Report on CRDCS Breaker Cabinet Seismic Qualification

This report, pursuant to 10 CFR 50.53(e) on Significant Deficiencies, is to document the investigation of the significant deficiency in the seismic qualification on the Control Rod Drive Control System Trip Breaker Cabinets.

AC BREAKER CABINET
ATTACHMENT MODIFICATION

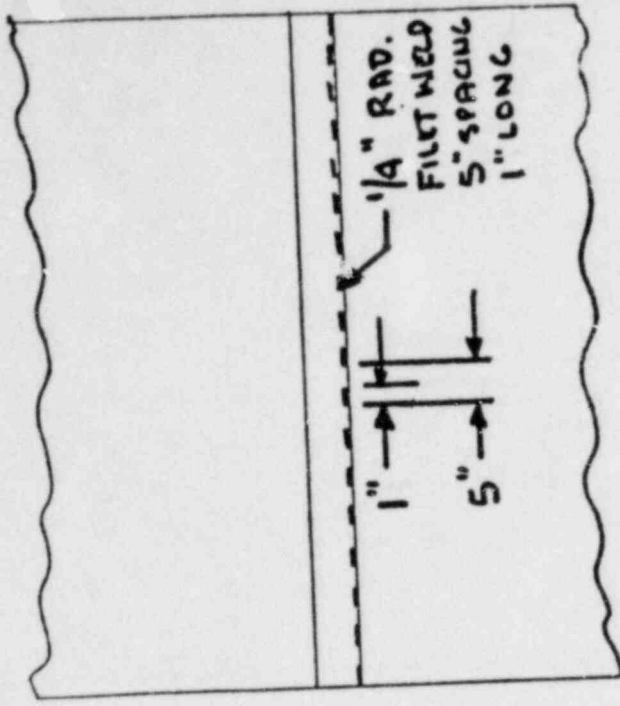
A reevaluation of the seismic qualification of the control rod drive control system AC breaker cabinets has found that the recommended attachment of the cabinet to the floor is inadequate to withstand the SSE acceleration levels.

In the event of an SSE, the AC Breaker Cabinets could, as per the finite element stress analysis, break loose from the floor mounting. With the cabinets unattached, the random motion or even falling over could cause accelerations of the breakers that have not been analyzed or damage to the breakers, wiring, or connections which could compromise the ability of the breakers to trip the control rods. Analyses cannot show that the failure will always be fail safe. Therefore, the deficiency in the design of the structural attachment of the AC Breakers Cabinets to the floor could adversely affect safety. This problem is thus considered to be a Significant Deficiency as per 10 CFR 50.55 (e).

The attachment of the AC Breaker Cabinet to the floor has been redesigned (see attached figure). Depending upon the arrangement at the particular site, either additional bolts will be included or a series fillet welds will be added to increase the attachment strength. Each plant with a construction permit or operating license is being evaluated on an individual basis. Newer plants are employing cabinet holddown designs which will assure the ability to withstand SSE loadings.
